Appendix II-E
Form 2 Packages

CU Certification of Completion

CU BACKFILL/ENGINEERED CAP COMPLETION APPROVAL - FORM 2						
Reporting Date	11/24/2009	Placement Start Date			10/28/2009	
CU Number	1	Placement End Date			11/20/2009	
Approximate CU Centroid	Northing	1616824.789	Easting	735165.184	NY State NAD 83	
CU Size	3.39	Acres				
Backfill Area	0	Acres				
Cap Area	3.39	Acres				
Backfill Surface Mean Tri+ PCBs Concentration (when required)		NA		mg/kg		
Number of nodes sampled		NA		mg/kg		
Backfill NA	Type of Backfill NONE	Reference to appropriate drawings attached to Approval Form 1				
Cap X	Type of Cap Type "B" Medium Velocity Cap Type "B" High Velocity Cap	Reference to appropriate drawings attached to Approval Form 1 CU1 Backfill and Cap Plan, 11/4/09				
CU Checklist		Indicate one of the following			Reviewer Initial Acceptance

Narrative Summary of Backfill and Capping and EPA Backfill and Capping Agreements

PARSONS
 COMMERCIAL TECHNOLOGY GROUP
 GE COMPANY - PARSONS PROJECT OFFICE
 BUILDING 40-1, 381 BROADWAY
 FORT EDWARD, N.Y. 12828 (518) 746-5311

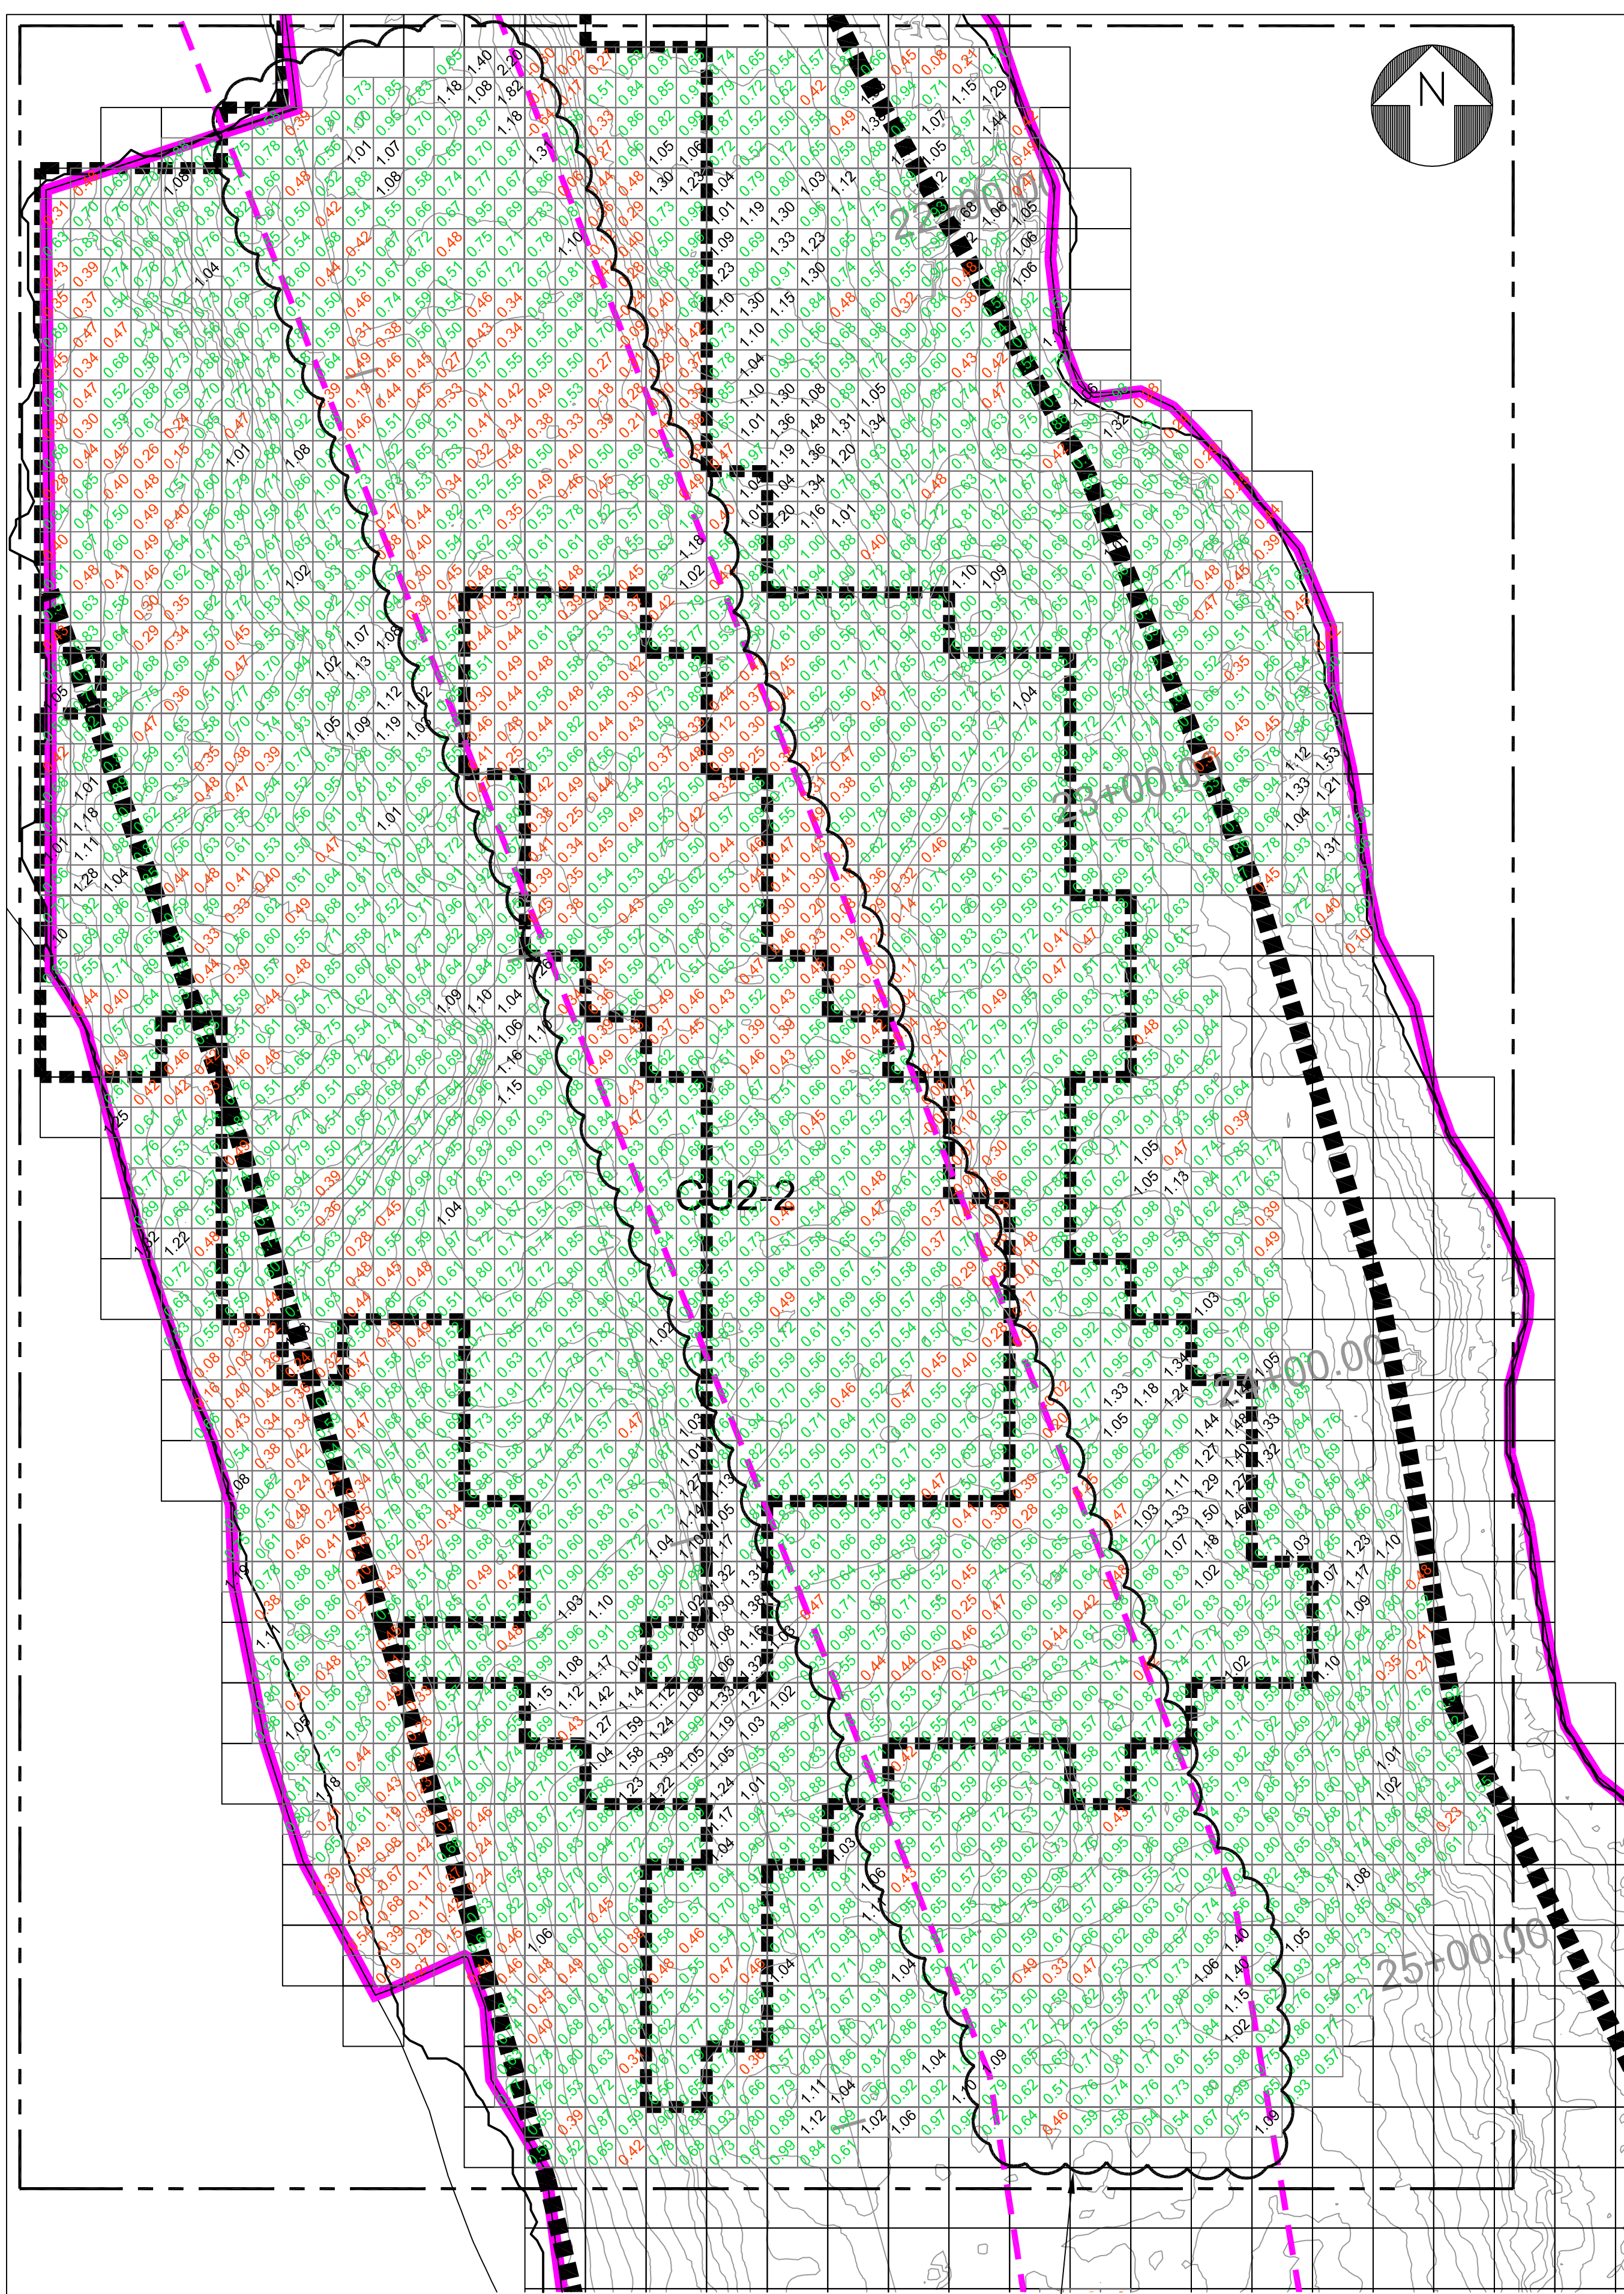
6. During a 3:00 PM meeting with EPA on November 13, 2009, GE presented a drawing and table showing the Riverine Fringing Wetland (RFW) area in Bond Creek. EPA agreed that backfill placement within the RFW area was acceptable. Table and drawing CU2 Bond Creek RFW Detail, dated November 11, 2009, is included in this package.

CU2
TYPE "B" CAP ARMOR LAYER
ACCEPTANCE SURVEY
(NORTH)

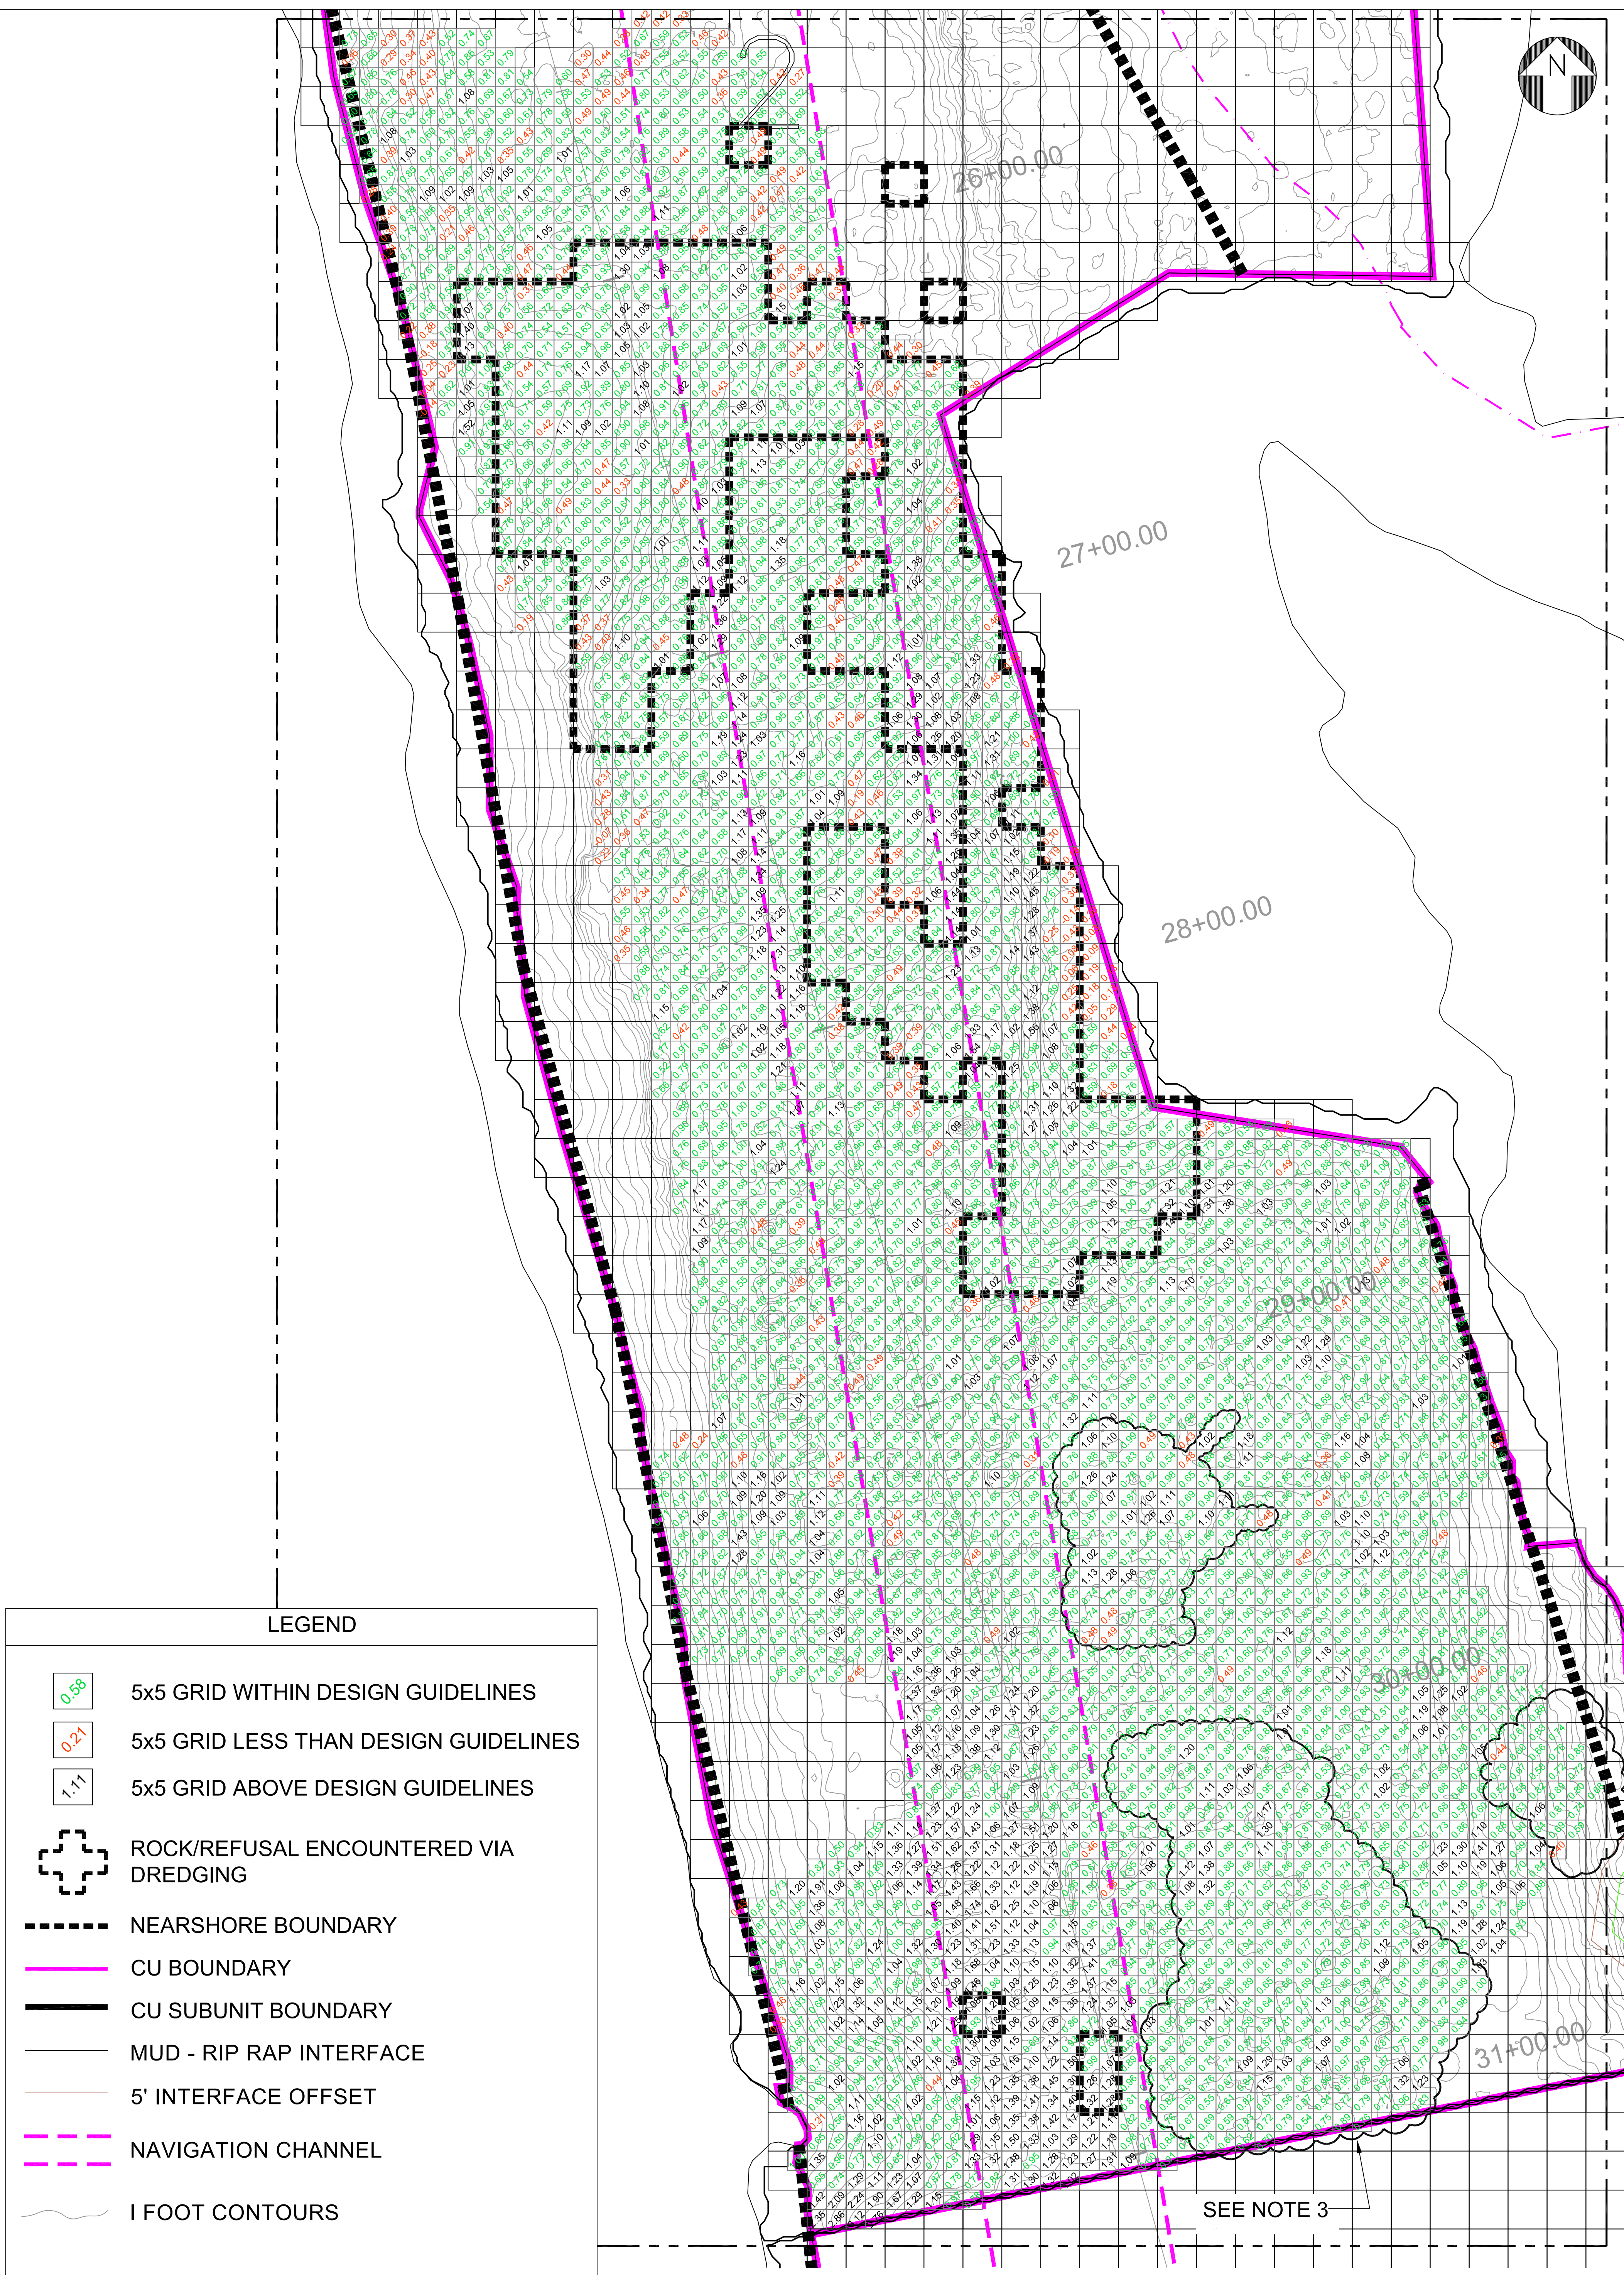
4. During a 3:00 PM meeting with EPA on November 9, 2009, GE presented a preliminary Cap Acceptance Survey Map on a 5' x 5' grid in CU 2. It was observed that the required thickness of armor stone in high velocity Type "B" caps in navigation channel areas had not been obtained but there was not sufficient depth to place additional Type "O" material. GE proposed that rather than place additional Type "O" material in these areas, that Type "N" material be placed. EPA agreed that placement of Type "N" material to finish high velocity Type B caps was acceptable in areas of the Navigation Channel with depth restrictions (see attached e-mail summary dated November 10, 2009).

5. During a 3:00 PM meeting with EPA on November 12, 2009, GE presented a Cap Acceptance Survey Map on a 5' x 5' grid in CU 2. EPA agreed that the cap thicknesses, as shown, were acceptable (see attached e-mail, dated November 14, 2009). The CU2 Type "B" Cap Acceptance Survey Drawing, dated November 18, 2009 is included in this package.

The cap armor stone layer in the southern half of the CU was agreed to be acceptable. It was agreed that portions of the cap armor stone in the northern half of the CU will require additional material. It was also agreed that placing additional Type O material in those areas would result in the cap being above elevation 105.2'. To avoid this situation we agreed that Type N stone could be placed to supplement areas where type O stone had already been placed.

CU2 BACKFILL PLACEMENT ACCEPTANCE SURVEY

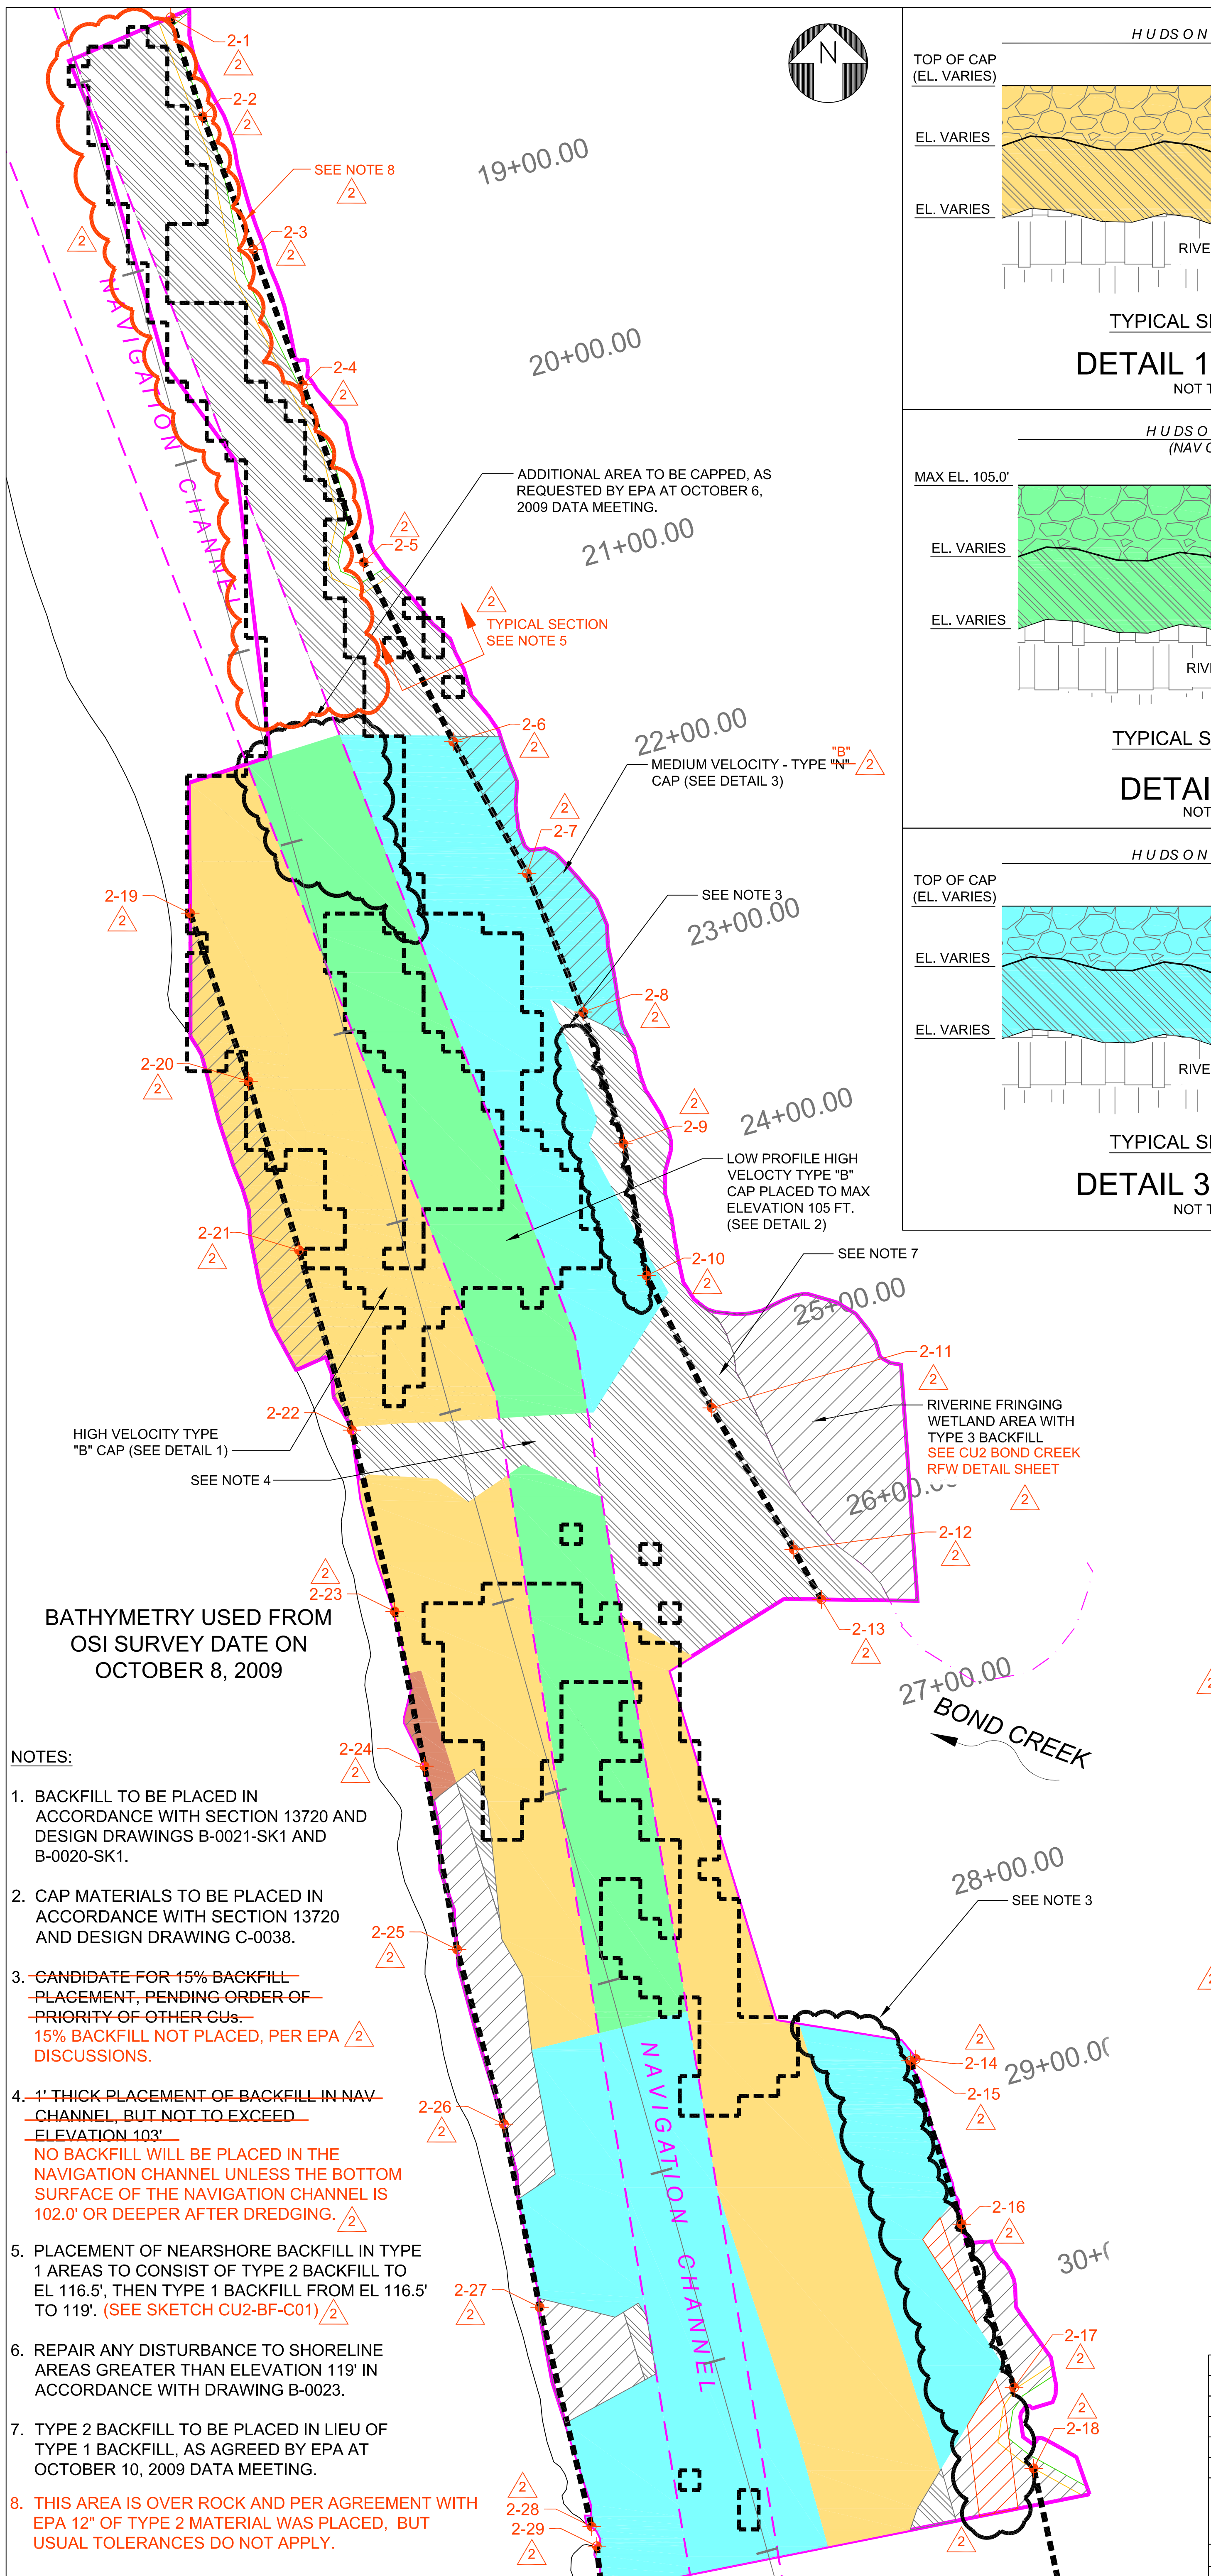
7. On November 18, 2009, GE provided EPA with acceptance surveys of the difference to backfill prisms on a 10' x 10' grid in CU 2. EPA agreed that the top backfill elevations, as shown, were acceptable. The Backfill Placement Acceptance Survey Drawing, dated November 18, 2009 is included in this package.
